# **Response to Written Comments on the Draft Sustainable Communities Environmental Assessment**

This document includes the comments received during the circulation of the Draft Sustainable Communities Environmental Assessment (SCEA) prepared for the 3200 East Foothill Boulevard Mixed Use Project.

3200 East Foothill Boulevard Mixed Use Project  
Responses to Comments on the Draft Sustainable Communities Environmental Assessment

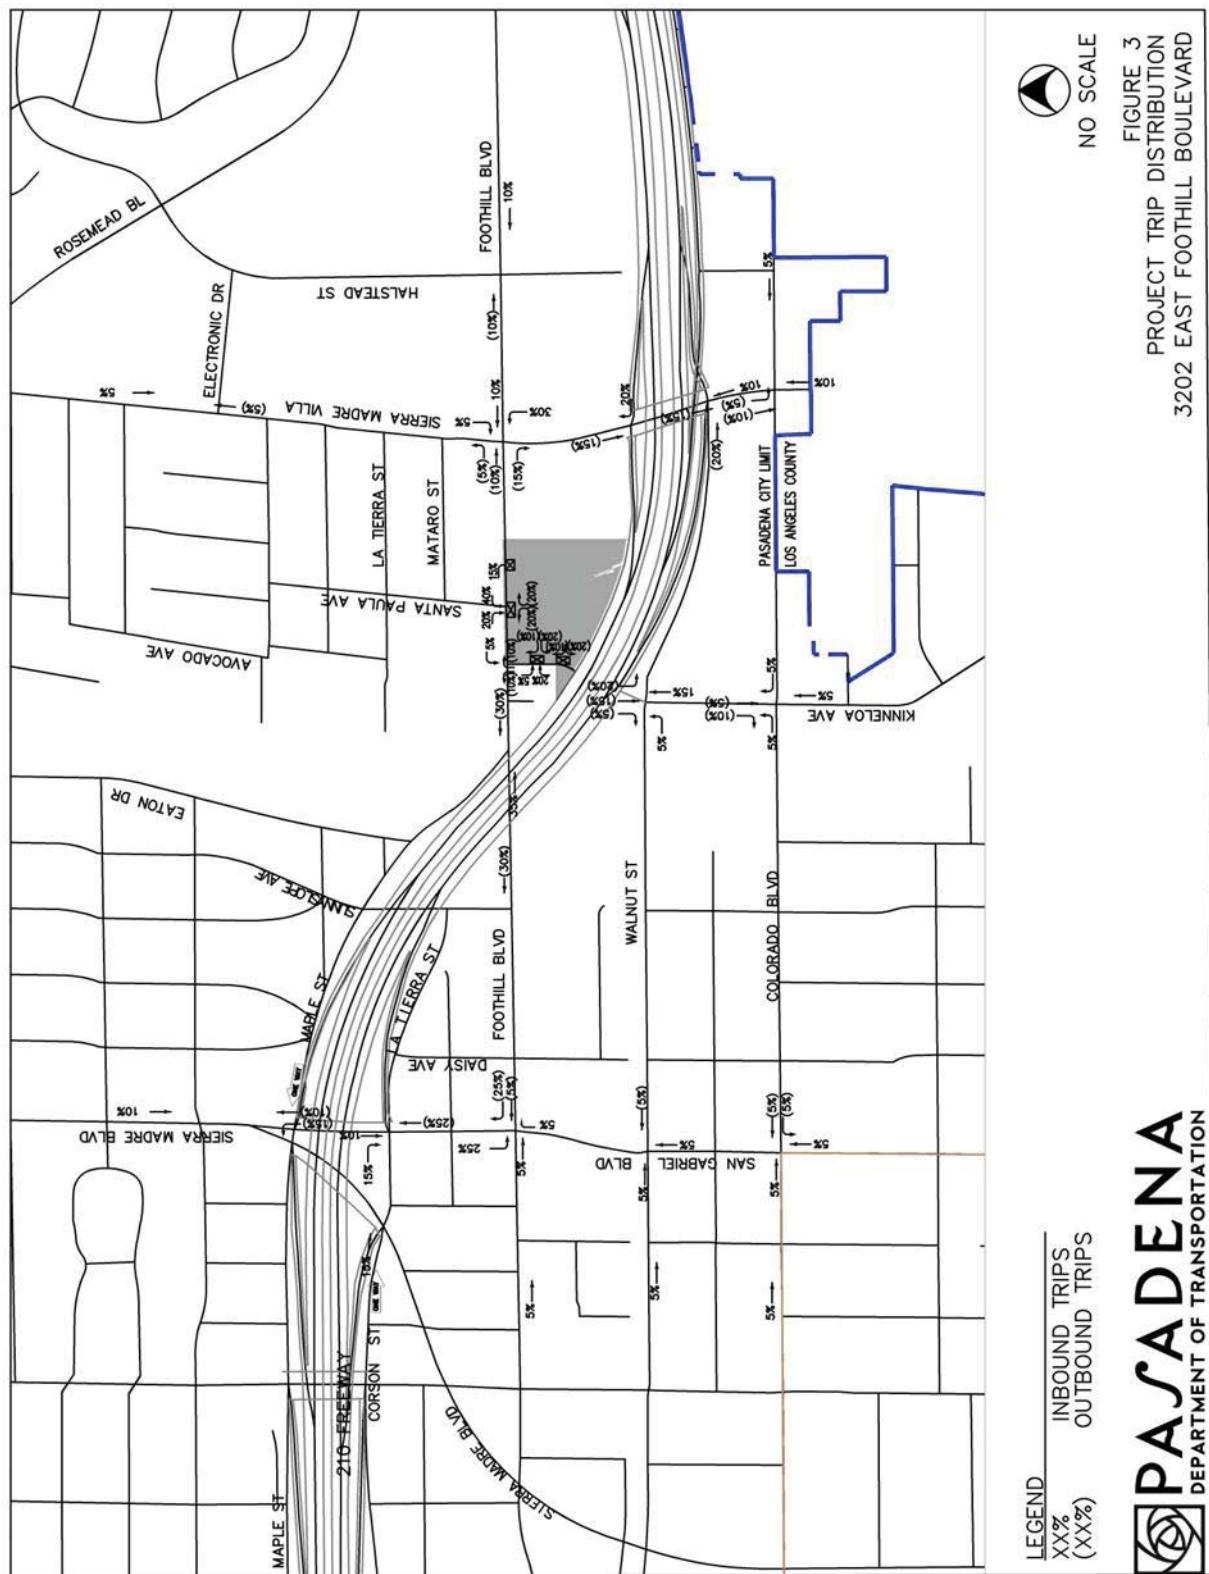
- Other than some (unprovided) numbers that were put into a computer model, there is no explanation for how the average daily and peak hour trip numbers were arrived at. | 14

- There is no breakdown on how many of those trips are expected to go in each direction, how far they would go, whether they would use the freeway vs staying on surface streets. Does the model generate estimates to that level of detail? | 15

### Response to Comment 15
